Item #8C:
Village Trustee Barry
Pathways Committee Report - South Schaeffer Road Pathway

**Subject: Watershed Development File #14-30-062
Long Grove Trail Connection to Buffalo Creek Forest Preserve, SWC of Checker
Road and Schaeffer Road, Long Grove, Lake County, Illinois
ISOLATED WETLANDS BOUNDARY VERIFICATION**

LONG GROVE TRAIL CONNECTION

SURVEYED WETLAND BOUNDARIES ON AERIAL PHOTOGRAPH

EXHIBIT 1

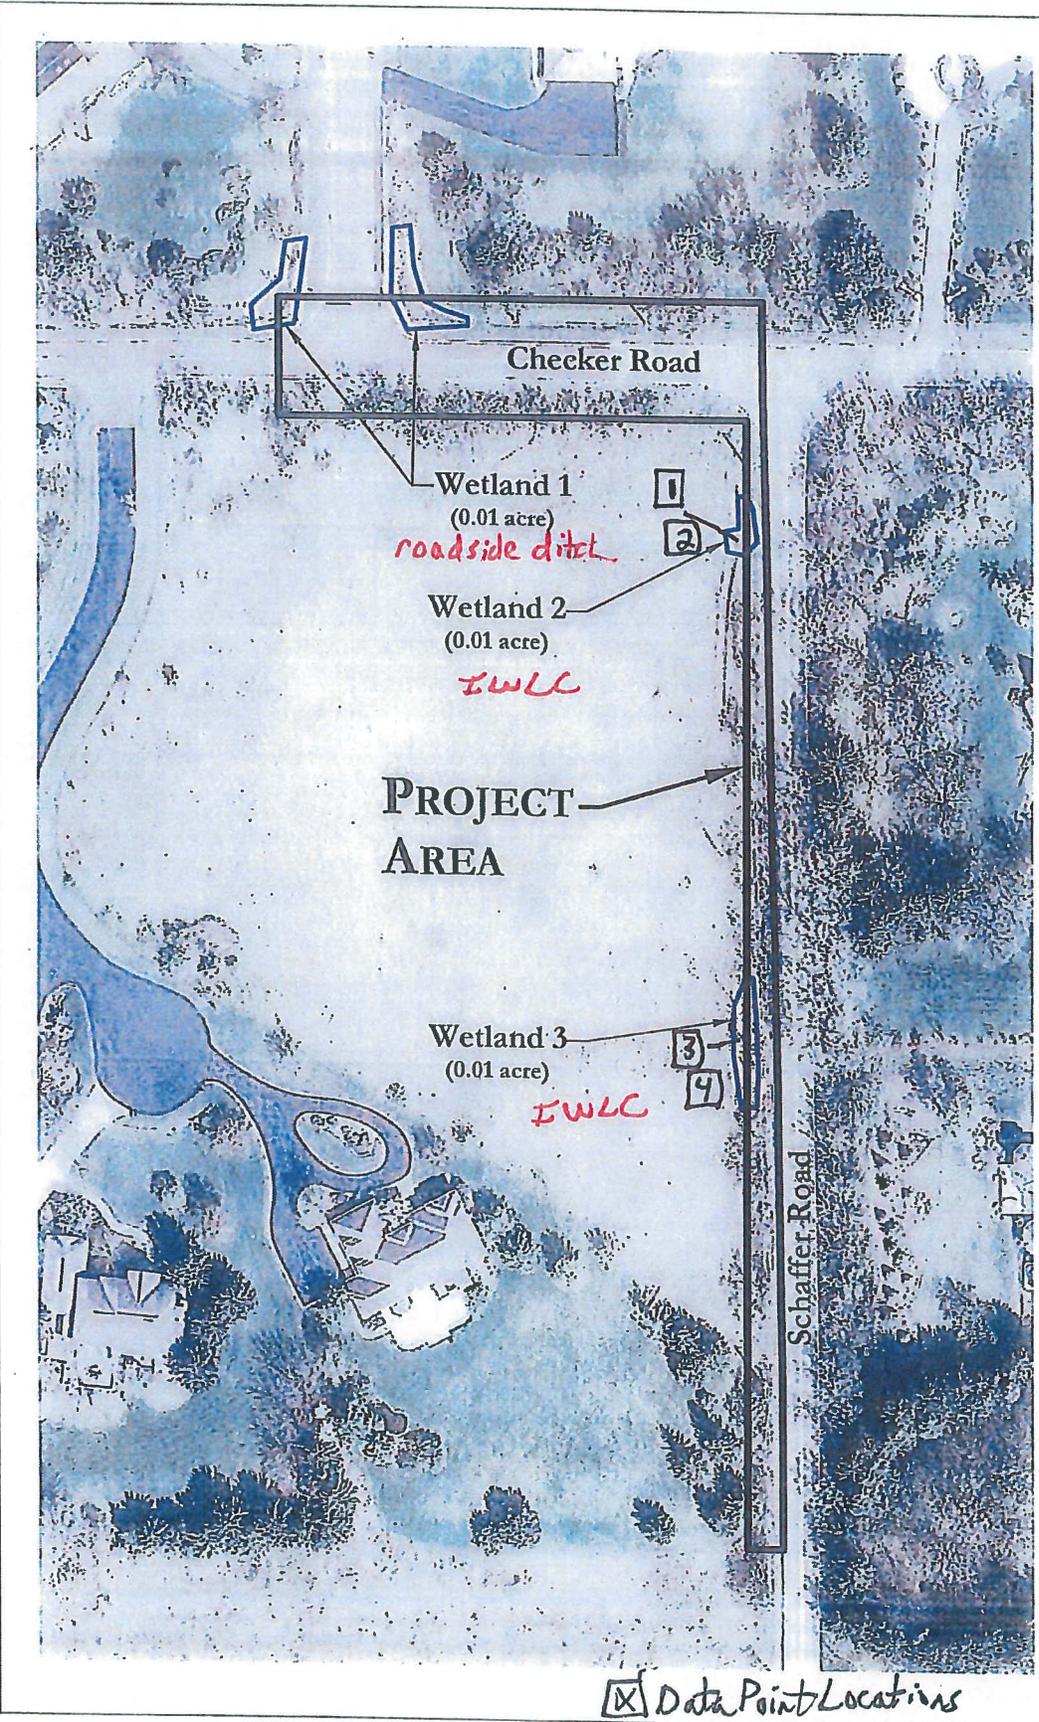
Based on our observations, SMC concurs with the flagged/staked boundaries of Wetlands 2 and 3 as delineated by Hey and as generally depicted on the enclosed Exhibit 1: "Surveyed Wetland Boundaries on Aerial Photograph," by Hey (not dated). The surveyed wetland boundaries will need to be included on the project plans for permitting purposes.
